Land Between Humber Doucy Lane and Tuddenham Lane, Humber Doucy Lane,
Ipswich, Suffolk (also referred to as: Land north-east of Humber Doucy Lane, Humber
Doucey Lane, Ipswich)

Proof of Evidence

Ruth Chittock BSc (Hons) MLA MSc

Planning Inspectorate Refs: APP/R3515/W/24/3350674 &

Figure 2. Indicative buffer section and plan

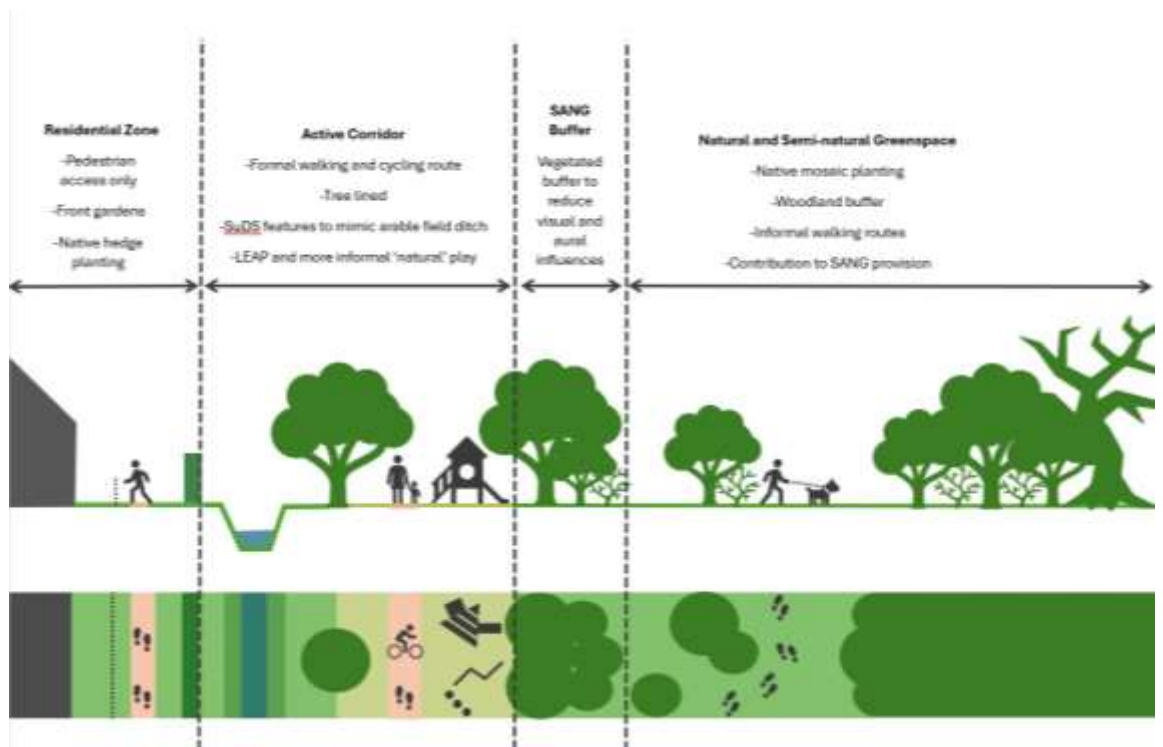
6.25 Figure 2. above shows an indicative landscape buffer treatment which would incorporate multiple active uses whilst also incorporating SANG space and achieving a successful transition from the urban edge to the countryside. Whilst the current proposals do include a number of these elements, ultimately the design falls down where the buffer is squeezed in size, and I am not satisfied that we have sufficient information to conclude that everything could be successfully accommodated in these areas.

Figure 3. Section B-BB from Illustrative Landscape Strategy drawing

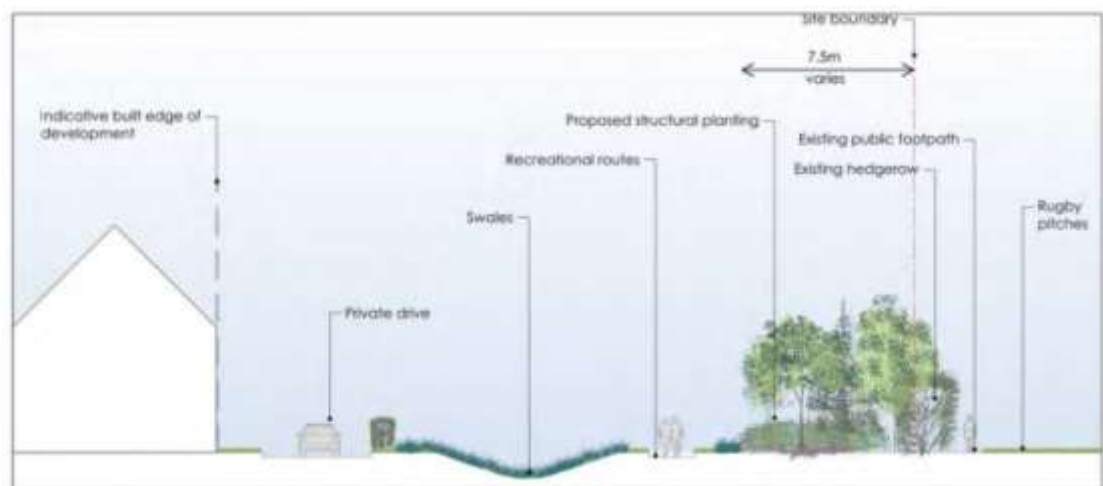
6.27 Landscape section B-BB on the same Illustrative Landscape Strategy drawing [AD17] is a more realistic illustration of how a lot of the buffer spaces would function, and this clearly provides limited room for meaningful multi-functional green infrastructure. This is shown below at Figure 3., which highlights a lack of plating to soften and screen the built edge and provide a proper SANG buffer.

Figure 5. Excerpt from the Play and Recreation Strategy drawing from page 119 of the DAS with undesirable LEAP locations highlighted

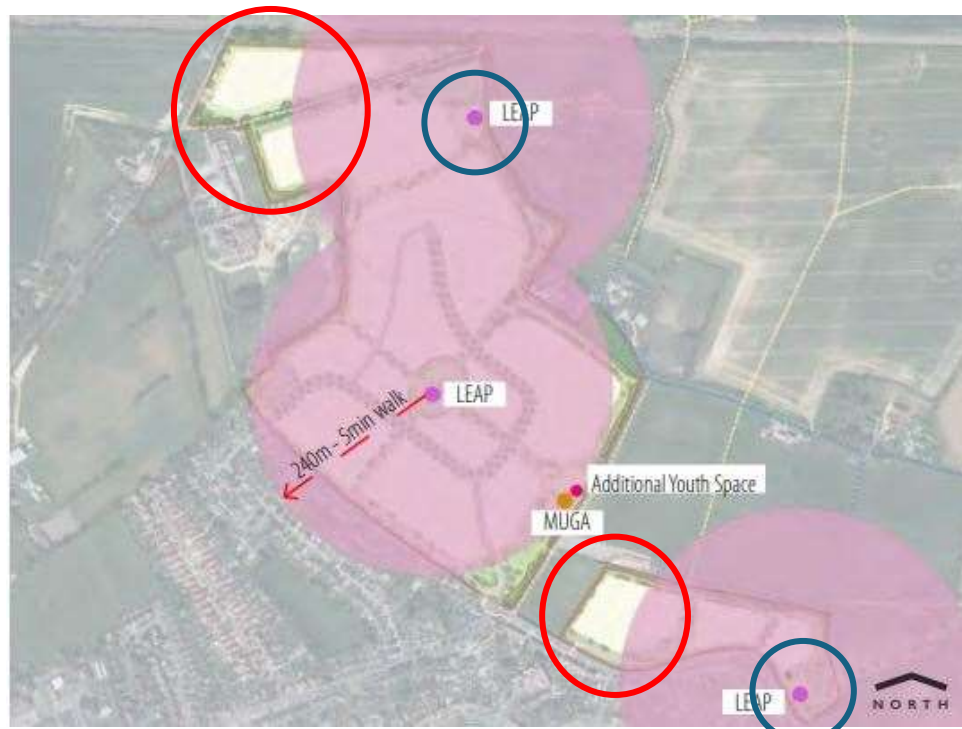
7.26 The Play and Recreation Strategy included on page 119 of the DAS [AD16] highlights that the location of the LEAPS to the far south-eastern corner of the site and the north-western corner of the site mean that several areas within the development would be outside the 5 minute walk radius, as required by the Healthy Environments SPD [SPD6] (Table 19, p.93).

7.27 Figure 5. below includes blue circles around the LEAPS which have been pushed to the edges and red circles which highlight the issues this causes with accessibility for all residents at the site, as there are areas to the west of Parcel D and Parcel E1 are outside the 5 minutes walk radius.

- 7.28 If the LEAPs were pushed further west into Parcels C and E2, the entire site would be within the access requirement. This could be achieved through the provision of more generous and meaningful green fingers of open space penetrating into the built areas. This improved distribution would also help with overlooking and visibility.
